Agenda Item #5

Application 2024-24-CA

Summary of Request:

Demolish existing one-story frame single-family residence.

CLIENT:
BHL FEDERAL
PROJECT LOCATION OR ADDRESS:
406 WISCONSIN AVE. MOBILE, AL 36604
BABBLER
EXTERIOR ELEVATIONS
OPTION 2 (MIRRORED)

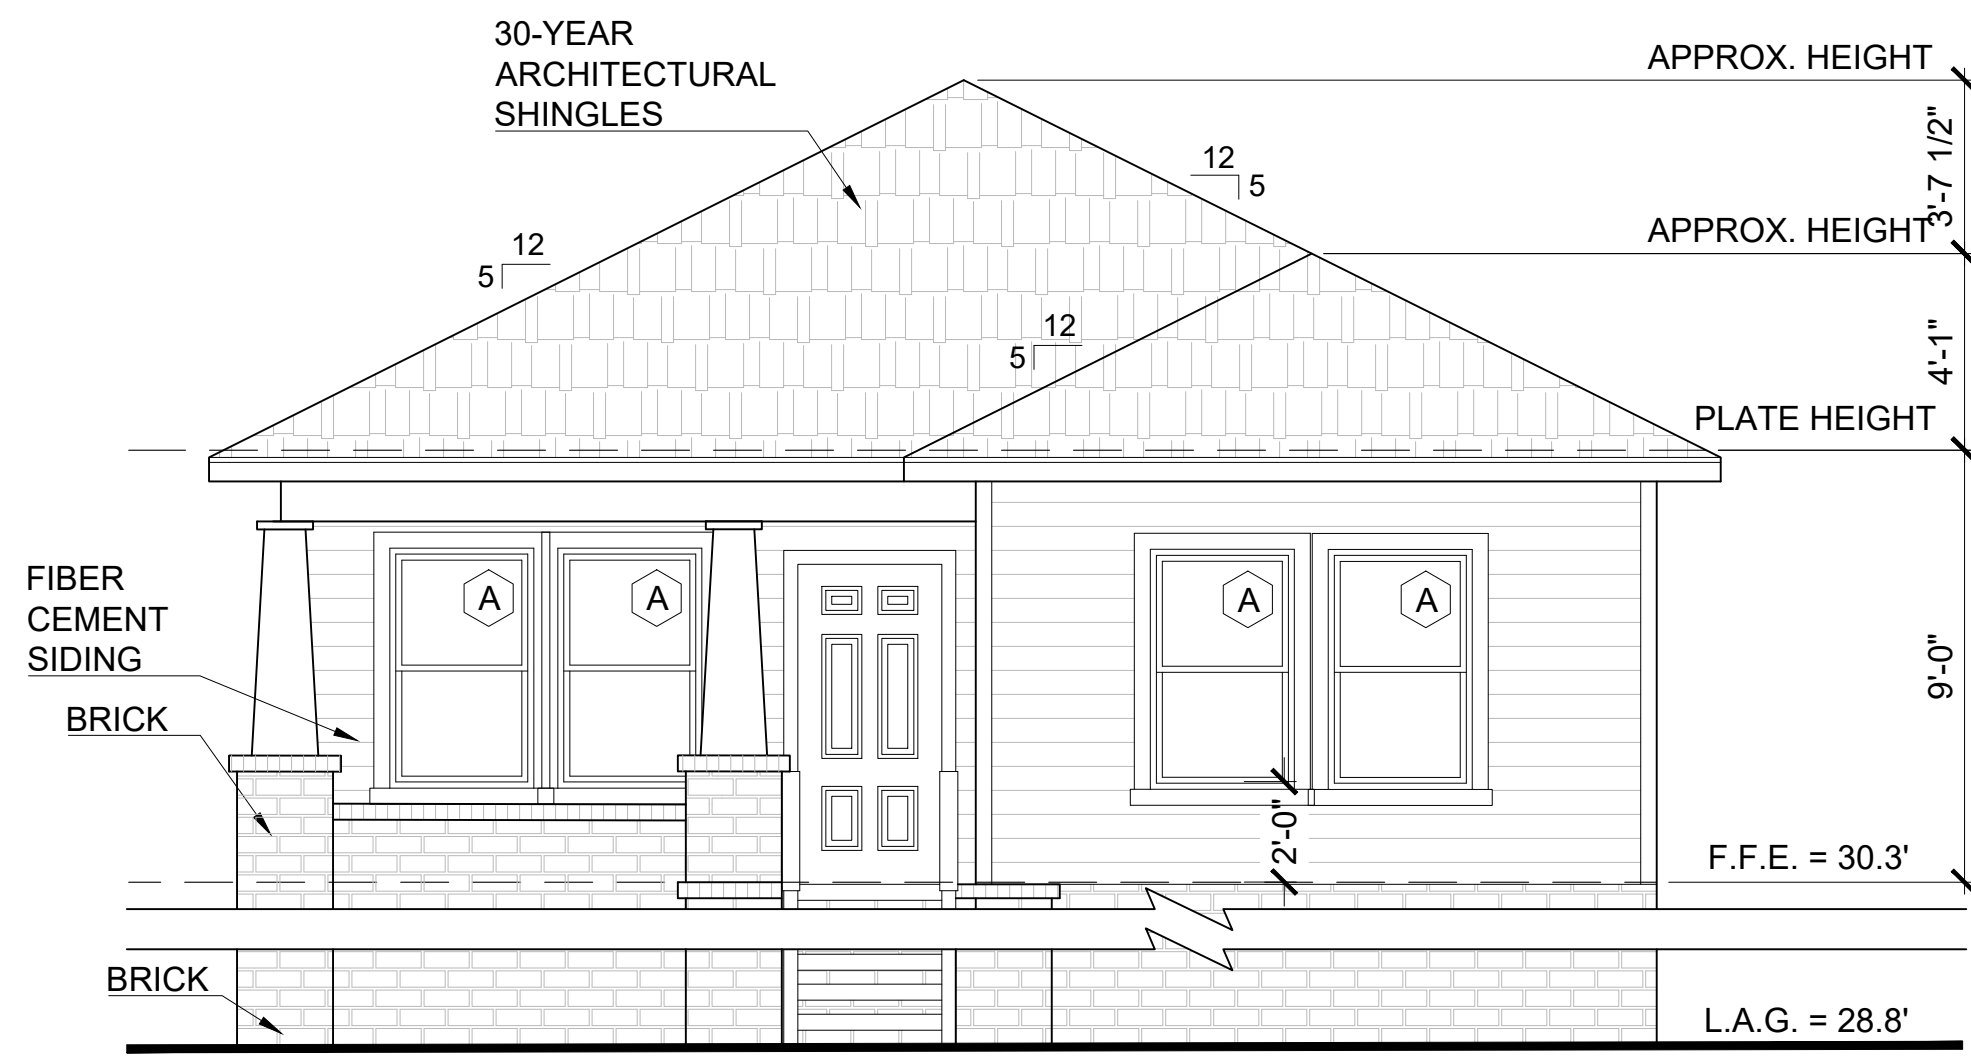
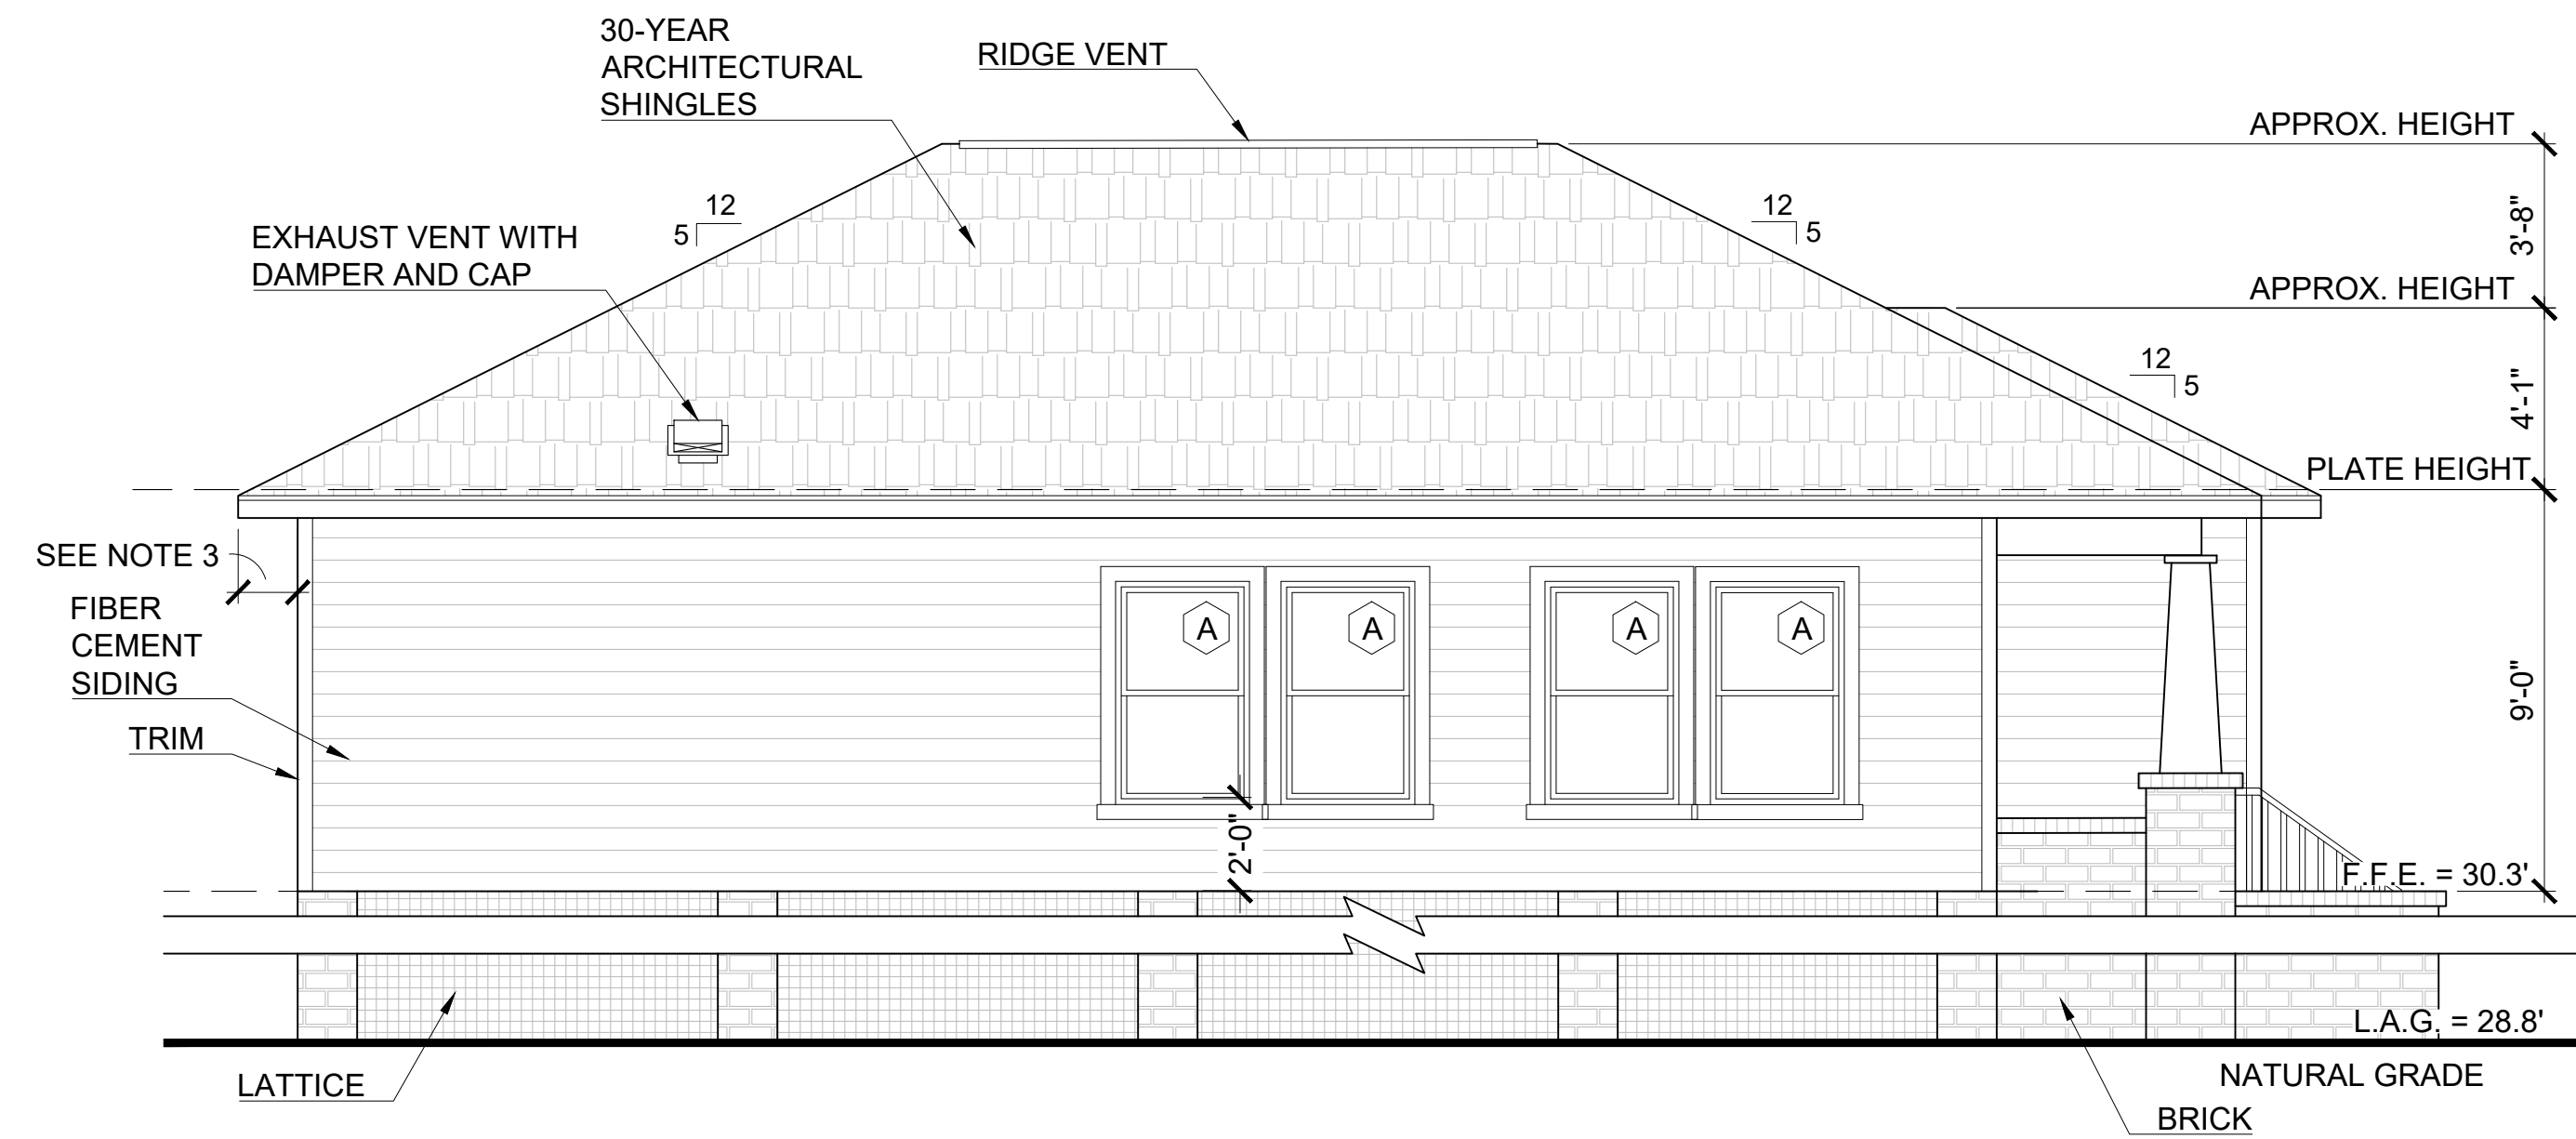
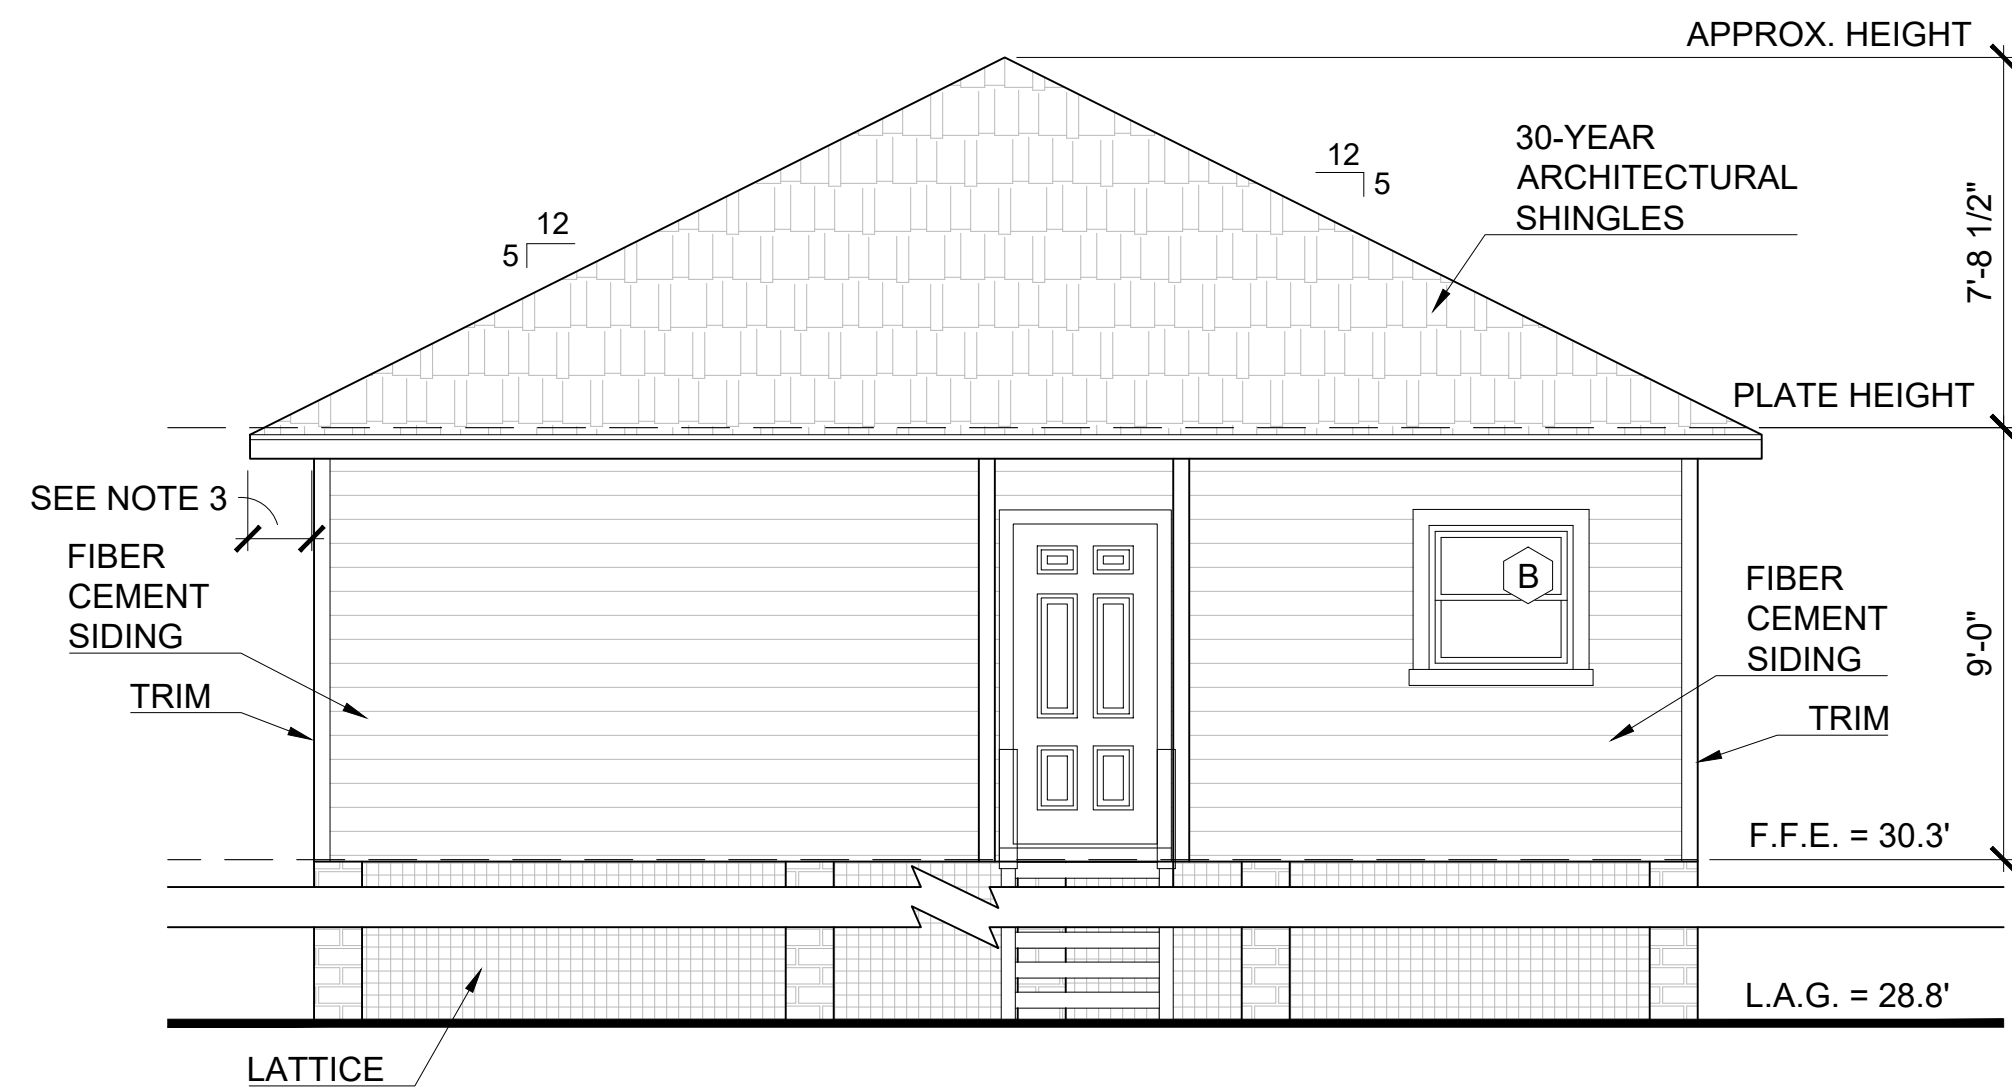
The historic structures in the immediate vicinity of the subject property vary slightly in size and details, but are fairly consistently one-story structures, rectangular in shape, some with off-set front or side projections. The proposed design for the subject lot is somewhat consistent in massing, proportions, and height with neighboring historic structures. It does lack offset side walls along the elevations expressed on many of the surrounding buildings which create a pattern of projections and recesses. The contributing buildings in its immediate vicinity sit on raised foundations which appear to be comparable in height to that proposed for the subject project. The intended use of masonry piers and lattice infill is likewise compatible with the historic neighborhood. (6.36,6.37, 6.43).

The street on which the subject property is located, along with immediate cross streets, are predominately populated with one-story gable or hipped roof bungalows of three or four bays, sitting on raised foundations and comprised of full or half-width front porches and restrained Craftsman style detailing such as exposed rafters, square columns, decorative brick detailing, and masonry knee walls. The majority of these residences possess long side elevations, many with occasional projections and recesses, and varying fenestration patterns. Proposed features of the three-bay, one-story bungalow-like design such as the hipped roof, front porch, projecting front bay, and foundation design would uphold conventions of the district, and assimilate the proposed new construction with neighboring historic buildings, as the *Guidelines* advise. The proposed materials of fiber cement siding, wood, and shingles are acceptable building materials within Mobile's historic districts, which respect the traditional building materials observable on nearby historic structures and throughout the historic district. The applicant has stated that the front and rear paneled entry doors would be of steel construction. Vinyl clad wood, proposed for the windows, is an approved material for new construction under the *Guidelines*. A three-over-one light configuration would be more appropriate than the proposed one-over-one pattern. The solid-to-void ratios along the side and rear elevations are not entirely compatible with those of nearby historic structures. Expanses of blank walls such as those seen on the south and west elevations in the submitted plans are not present on historic bungalows in the neighborhood. (6.38 - 6.42, 6.44, 6.45).
